Municipal Planning Commission Meeting
Thursday, September 17, 2026 at **6:00 PM**

AGENDA

REPORT TO THE MUNICIPAL PLANNING COMMISSION

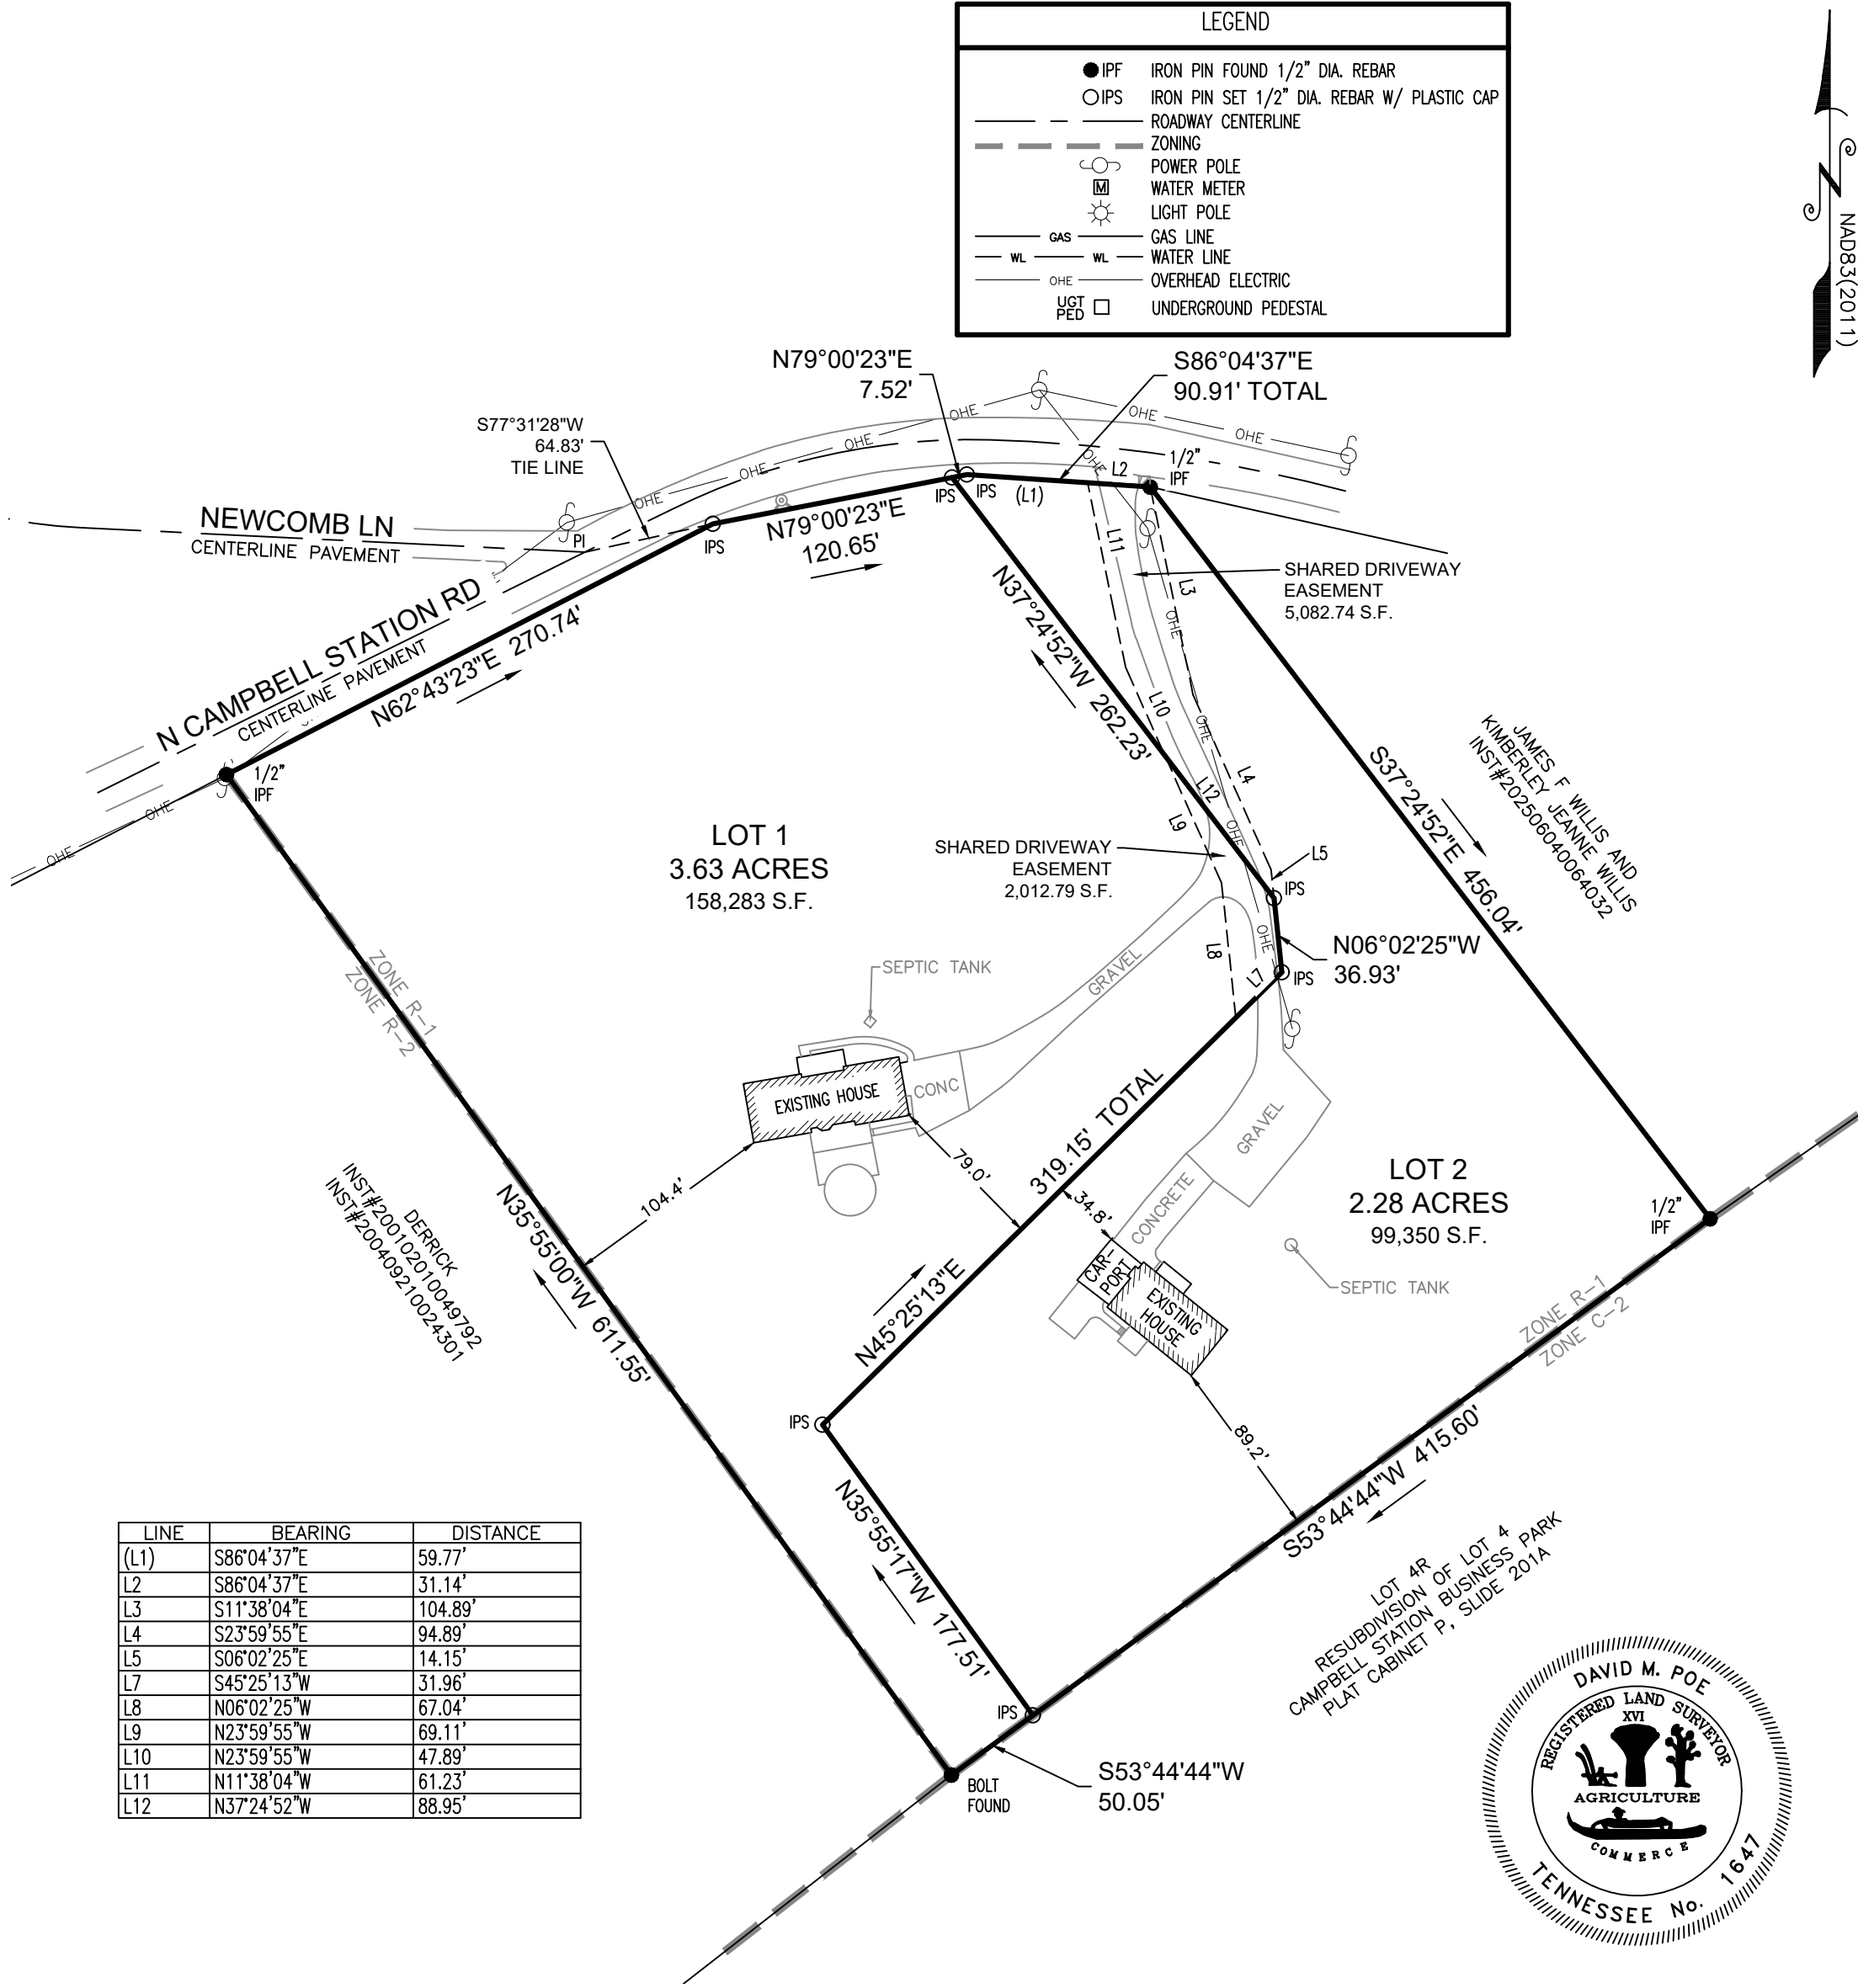
Based on the minor nature of the re-subdivision plat being requested at this time, the staff supports the requested variance. Since this property could potentially be divided further, the applicant has added a note that any additional division will require a pedestrian facility along the frontage and provisions for vehicular access to abutting properties.

For additional clarification and assuming the variance is approved, the staff would recommend the following note also be added to the

plat: “The variance request to omit the requirement in the Subdivision Regulations to construct a pedestrian facility along the frontage of N. Campbell Station Road in association with this specific plat was approved by the Farragut Municipal Planning Commission at their meeting on September 17, 2026 based on the minor nature of this re-subdivision. The variance is specific to the subdivision reflected on this plat, and in no way affects the requirement to provide a pedestrian facility in the future should the properties be further divided or the Town of Farragut chooses to construct, at their cost, a pedestrian facility along the N. Campbell Station Road frontage of this property.”

In terms of the plat, the staff recommends approval with the above-referenced note being added and required signatures obtained.

Plat. To approve the plat with the clarification note being added and required signatures obtained.

OVERALL SITE PLAN (BUILDINGS)

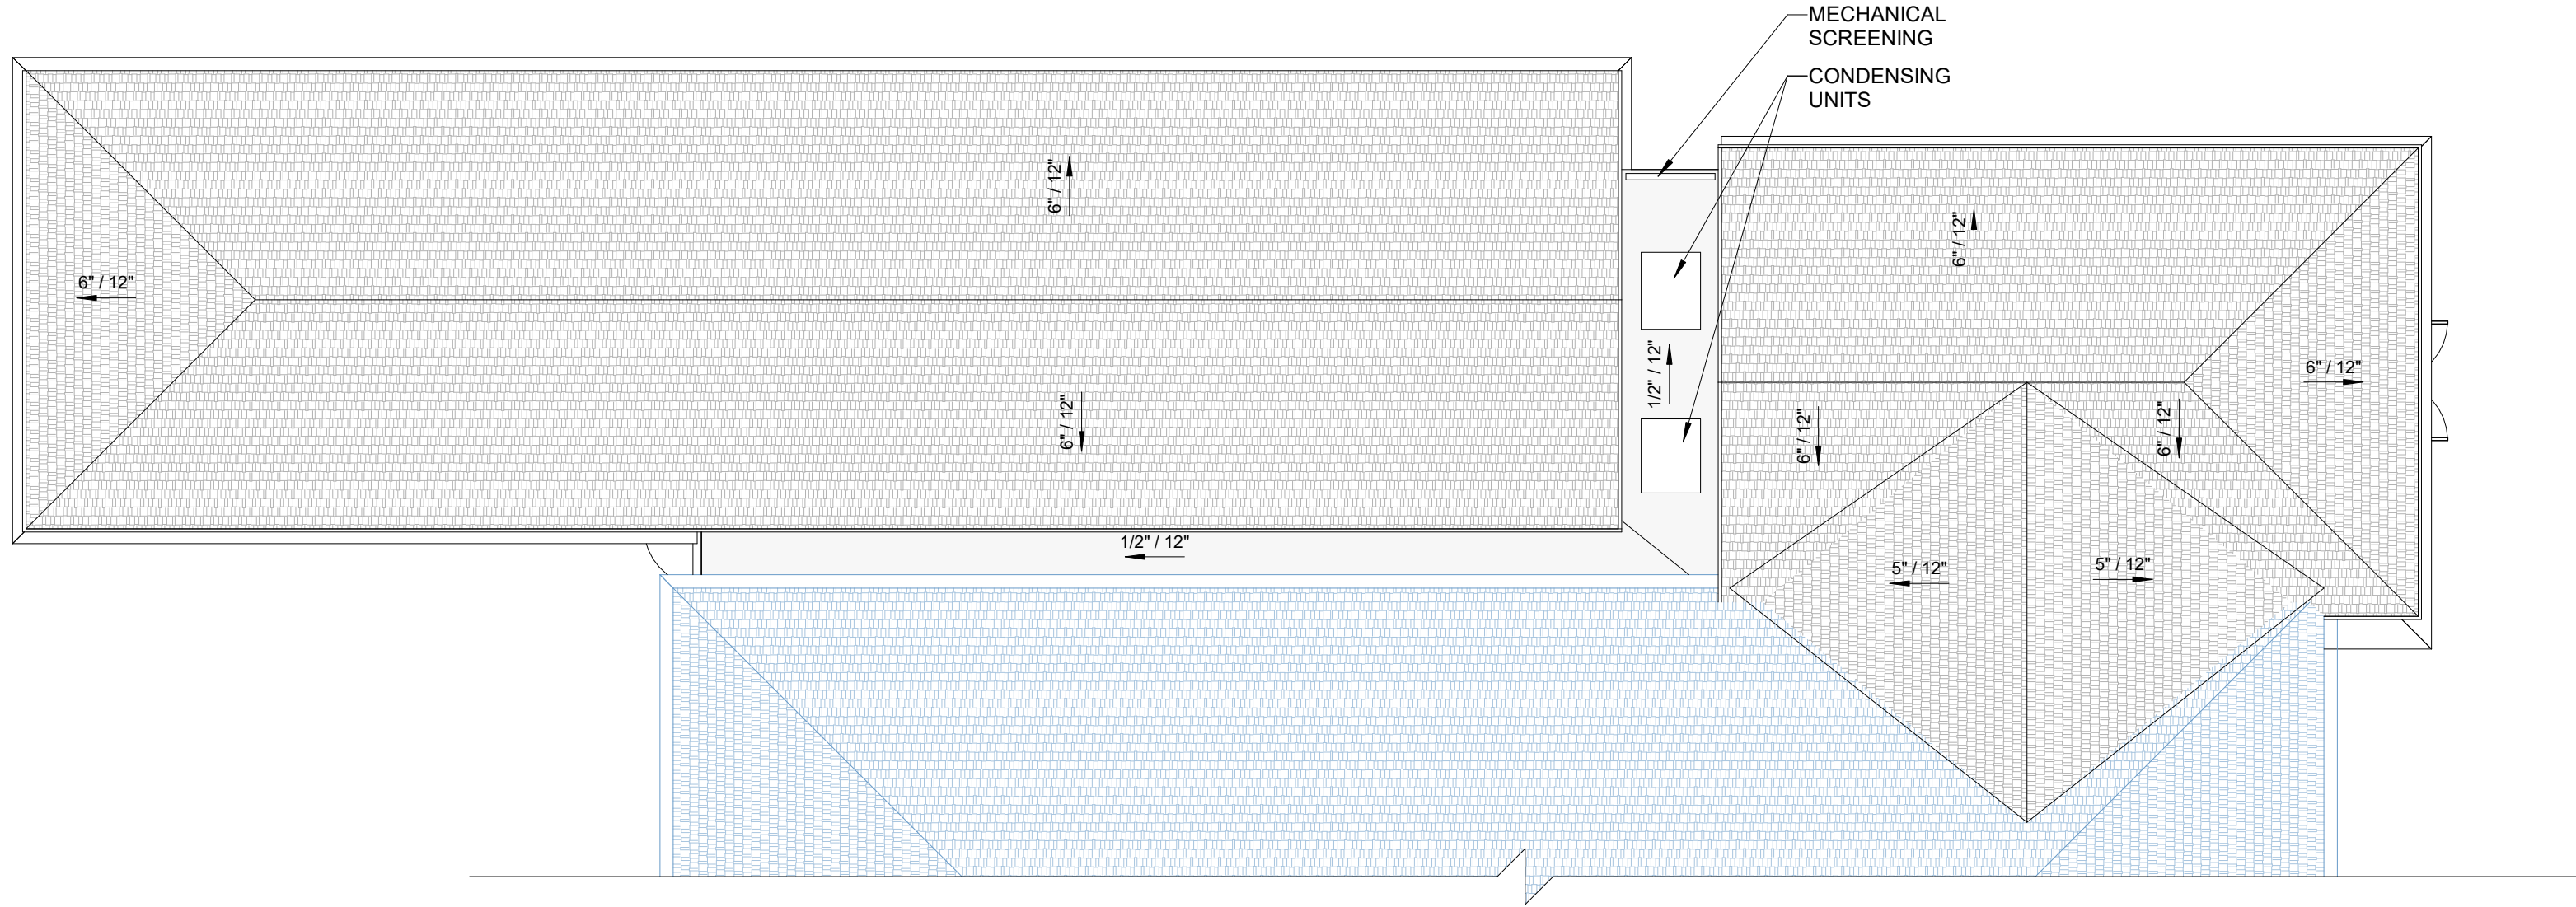
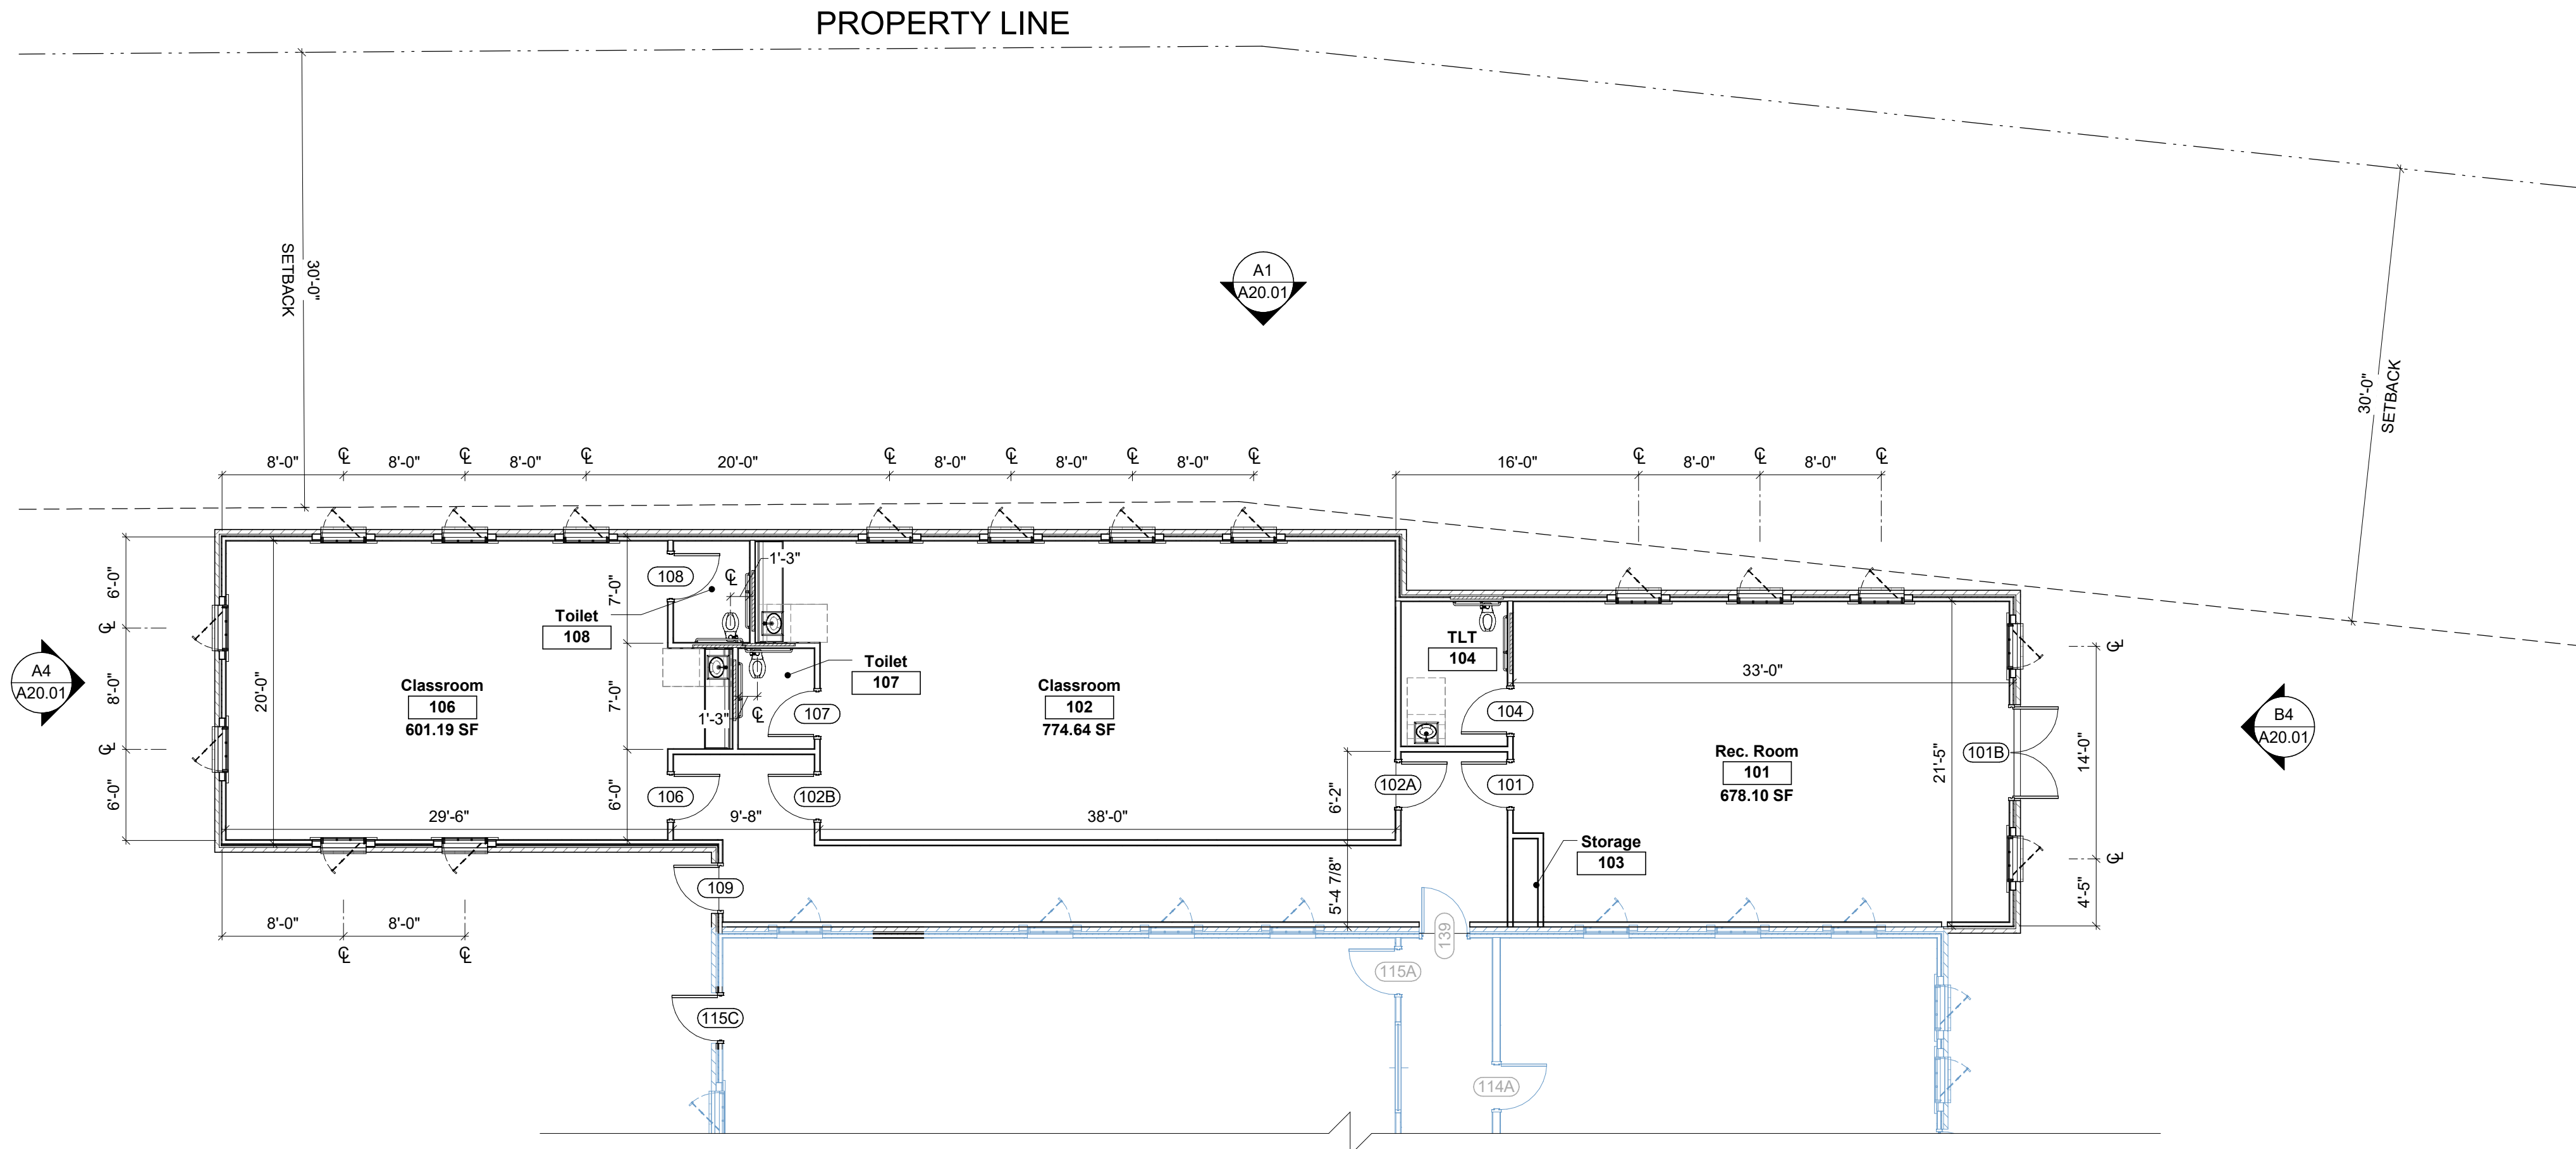
Introduction & Background: This item is for discussion purposes only. As shown on the site plan included in the packet, the Goddard School off Loudon Road is planning to expand with a roughly 2,800 square foot addition. The site plan for this project was conditionally approved at the July 16, 2026 Planning Commission meeting. One of the approval conditions was that a fenced outdoor play area, per the Town's Zoning Ordinance, is provided to meet the requirement that at least 100 square feet is provided per child permitted by the State license or a text amendment is approved by the Board of Mayor and Aldermen to follow the State of Tennessee requirement, as applied to the square footage needed for fenced outdoor play areas.

Discussion & Recommendations: In Chapter 4, Section V., of the Town's Zoning Ordinance, development requirements specific to day care facilities are provided. One of those requirements that the applicant's site plan would not satisfy is the requirement for a fenced outdoor play area of not less than 3,000 square feet or 100 square feet per child permitted by the State license, whichever is greater, is provided.

The applicant's request would lessen the current Town requirement but provide more outdoor play area than the State requirement, because the allocation would still be based on the number of children permitted by the State license rather than the number of children using the area at one time — which is very difficult to measure. Though this is for discussion purposes only, the staff is in agreement with the applicant's request since it would still provide more fenced outdoor play area than required by the State.
